**COMMISSION OF ARCHITECTURAL REVIEW
STAFF REPORT
August 22, 2017, Meeting**

8. **COA-021096-2017** (C. Jefferson)

**812 Jessamine Street
Union Hill Old and Historic District**

**Rehabilitate the exterior of home
and add a 2nd story rear addition.**

1905 Sanborn Map

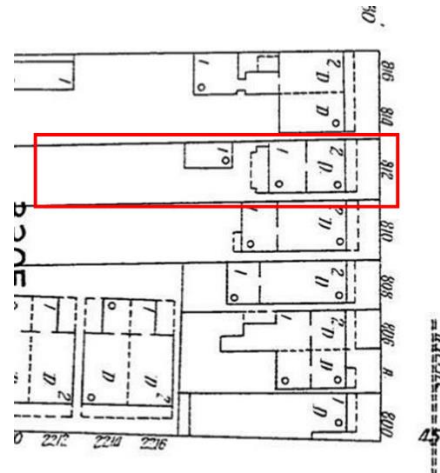
The existing home is a 2-story, 3-bay shallow gable-roofed frame dwelling with a box cornice. As seen in the earliest Sanborn map from 1905, the home was a two story structure with a single story rear wing and a side porch. Staff believes the existing single story gable roof section is what is shown in the 1905 Sanborn. Later Sanborn maps show the side porch was enclosed, and it appears the bathroom which projects past the rear wall was add after 1952. Though there is no rear alley behind the structure, the rear of the home is visible from both Burton and Cedar Streets.
